Applicable Urban Design Priorities that Project Should Achieve

1600 Pacific Ave.

LTV MIXED-USE

1600 Pacific Avenue, Dallas, Texas 02.19.13 maa.2012175

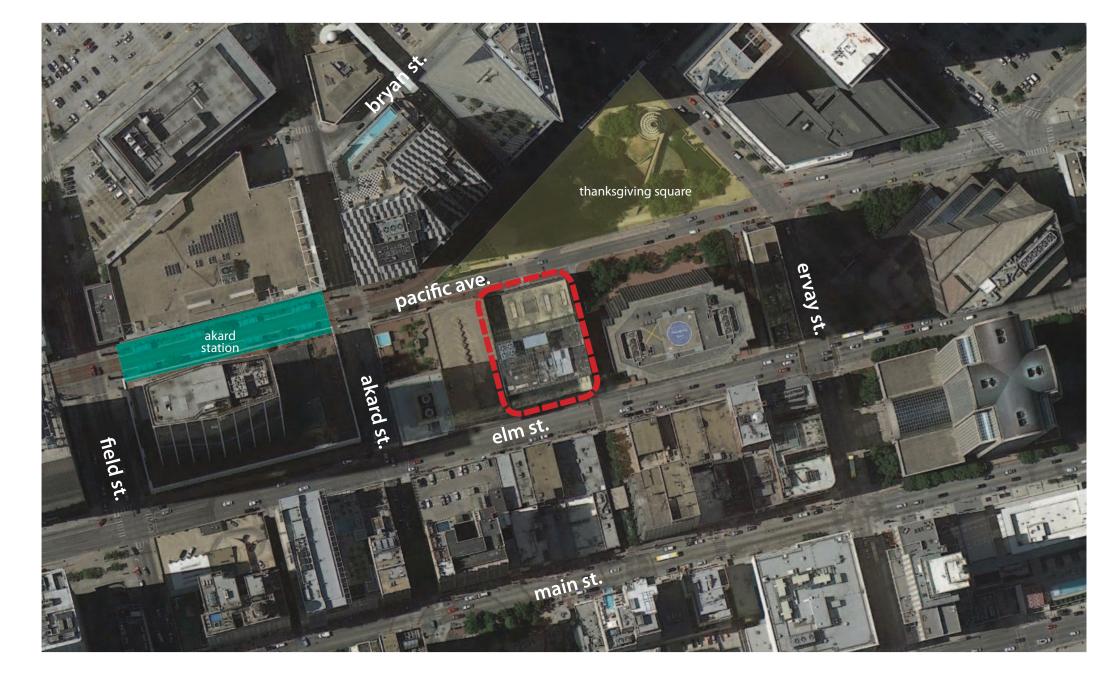
- [1] Designing the proposed hotel entry drive as a shared and inviting pedestrian pass through The proposed hotel entry drive should be designed as a functional, inviting pedestrian connection linking Elm St. and Pacific Avenue. This also creates a new link from the Stone St. pedestrian connection to Thanksgiving Square. Special considerations should be made regarding sidewalk drive entries, materiality, lighting, and the safe blending of zones for pedestrian and vehicle.

- [2] Strengthening DART linkage and neighborhood connectivity through enhanced streetscape and pedestrian realm amenities Special attention should be made to the quality of streetscape linking the project to the adjacent DART station. By continuing a strong pattern of street trees, pedestrian friendly sidewalks, and pedestrian amenities and crosswalks, individual projects ensure and contribute to the overall success of a coherent and appealing pedestrian network throughout downtown. Careful attention to details such as curb treatment and crosswalk transitions are crucial to pedestrian realm continuity and connectivity.

- [3] Organizing ground floor uses to best utilize opportunities to foster sidewalk interest and activity while connecting to adjacent active uses Careful consideration should be made to the location of proposed ground level uses, and how they interact with the pedestrian realm. Uses should respond to local active zones, as well as create opportunities to add activity and interest to the street.

- [4] Minimizing or consolidating loading and utility zones along direct street frontage While there are clear challenges due to existing site conditions and programmatic need for utility uses, careful consideration should be made to thoroughly research solutions to minimize impacts of utility zones and drives on the pedestrian experience. Drives should be treated to have minimal impact on physical and visual continuity of the sidewalk.
